Technical Bulletin

TCK42CRD-06 - 2.5 YD25DDTi

Design Differences Between FAI and Original

TB0056

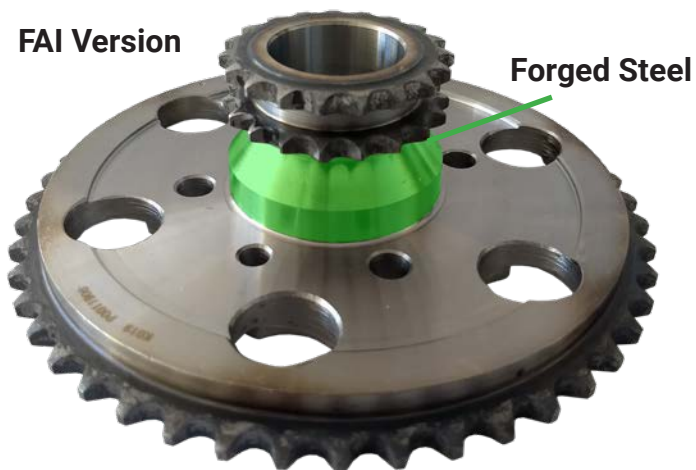
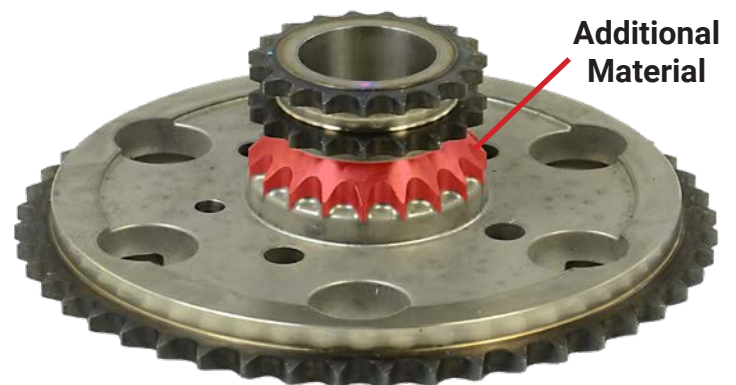
The image below shows the injection pump sprocket which has been manufactured by FAI compared with the original manufacturer design.

The sprocket supplied by FAI is a direct replacement with the only difference being the material & production methods used during manufacture.

The FAI design is strengthened by using forged steel rather than powder metal. Due to the added strength of the FAI version, the junction between the duplex and the simplex sprockets doesn't need the additional material, as indicated below.
